**SUNDRY NOTICES AND REPORTS ON WELLS**  
*Do not use this form for proposals to drill or to re-enter an abandoned well. Use form 3160-3 (APD) for such proposals.*

Well Name: MIRO 35 FED 1		Field: WILDCAT-WOLFCAMP	
Location: 1250' FNL & 1000' FWL; SEC 35-T26S-R35E		County: LEA	State: NM
Elevation: 3066' KB; 3040' GL; 26' KB to GL		Spud Date: 4/23/00	Compl Date: 10/9/00
API#: 30-025-34897	Prepared by: Ronnie Slack	Date: 1/16/18	Rev:

PROPOSED P&A WELLBORE

**Permanent Abandonment of Federal Wells**  
**Conditions of Approval (LPC Habitat)**

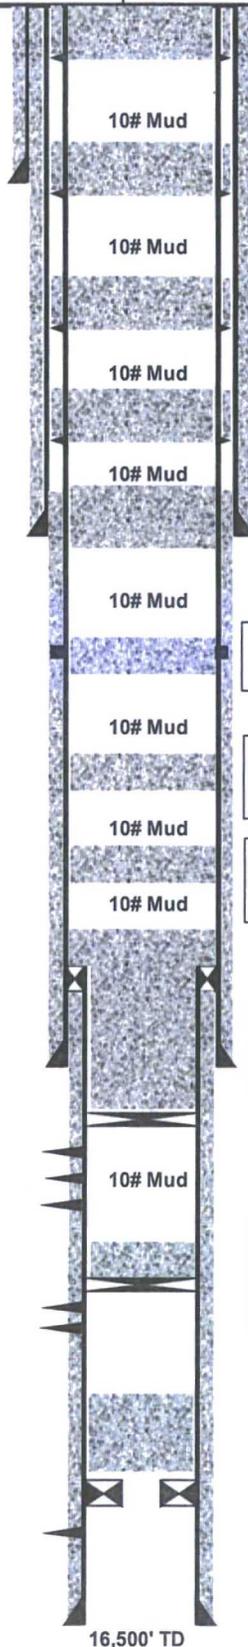
Below ground level dry hole marker required

\*\* BLM REVISED \*\*

Del. 5116

BS 9144

WC 12226

St 14094

At. 15230

MR 15940
